Mayc's Garments Ltd.

House No. 18/19, Road no. 1, Block –KHA, Section-6, Mirpur, Dhaka.
(23.805996 N, 90.367568 E)

2nd April 2018

Foundation layout plan

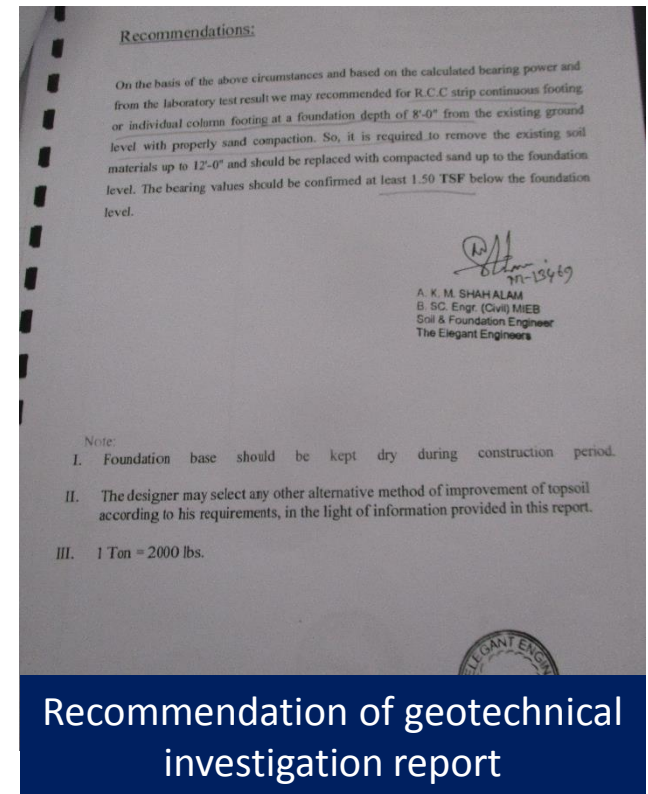
Design check required for the foundation system

As per soil test report, R.C.C. strip footing or individual column footing was recommended. But during inspection, pile foundation was observed on structural drawing of the building. No recommendation was found on soil test report regarding pile bearing capacity.

Cursory calculation indicates that pile appears to be stressed above normal design limits. Factor of safety (FoS) is less than the minimum requirement of BNBC. Factory engineer is required to review the adequacy of pile considering actual bearing capacity of soil and comply with BNBC.

Column Layout

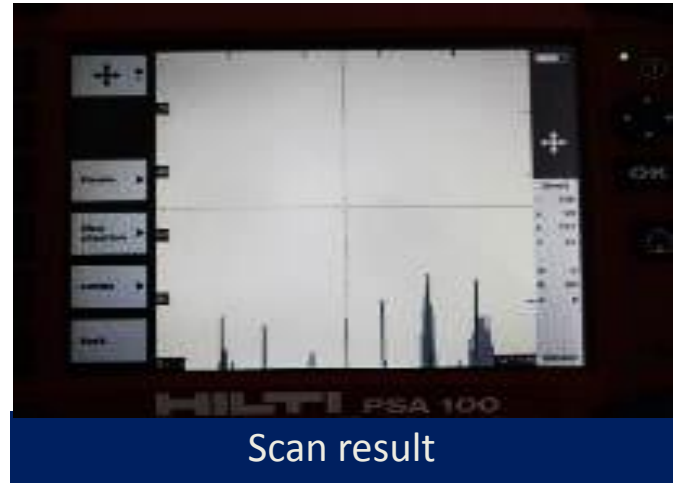
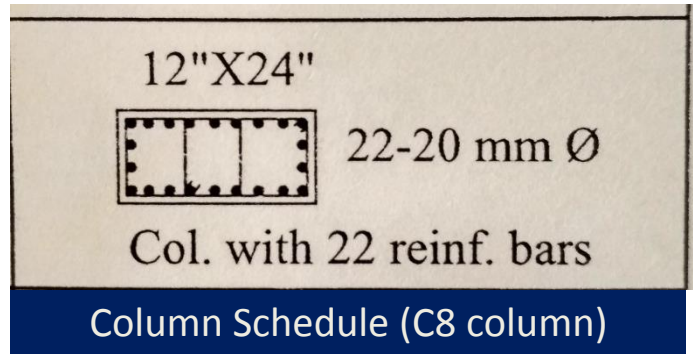
Discrepancy between provided drawing and on-site condition

Nos. of rebar in all C-8 type column at basement level does not match with provided column schedule. 16 nos. of rebars were found by ferro scan where as 22 nos. rebars were shown in column schedule.

Beam Section (FB-4 Type)

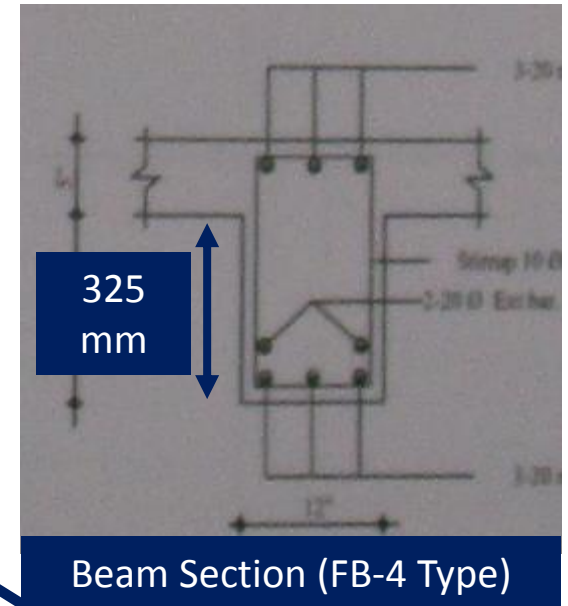
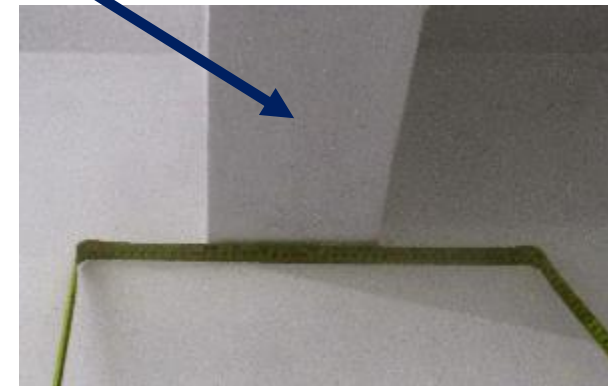
The width of marked FB-4 type was found less than the provided drawing section in every floor. Factory is required to revise As Built drawing as per actual condition.

The width of the marked FB-4 type beam was observed 150 mm instead of 325 mm.

Slab opening covered by steel sheet

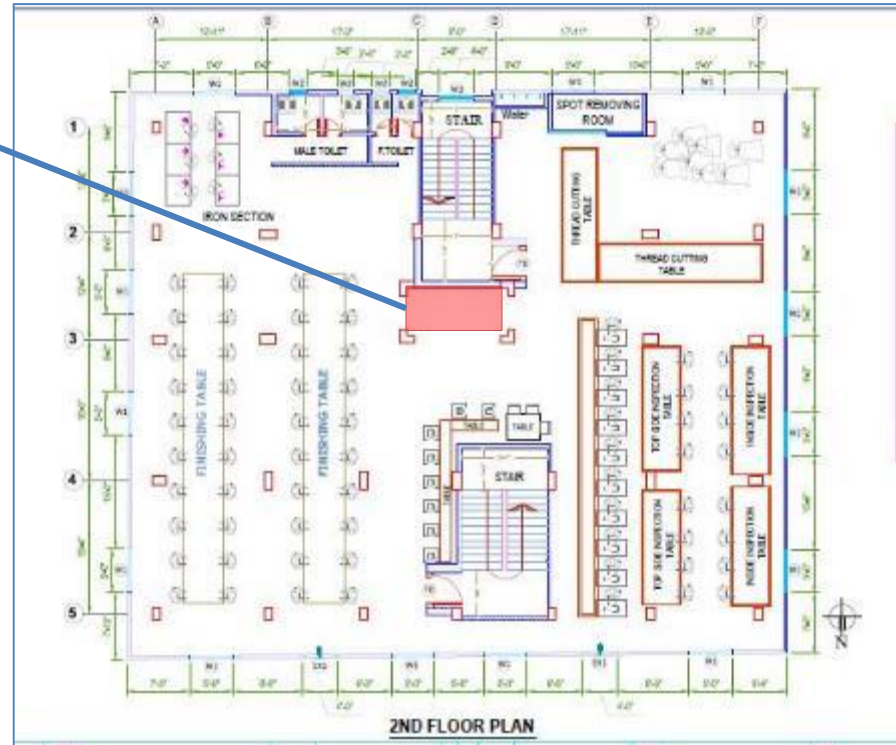
Slab opening was found on GF to 3rd floor slab which was covered by steel sheet supported by angle. Factory is required to replace the steel sheet as per engineer's recommendation.

Steel sheet poorly connected with RC slab by welding
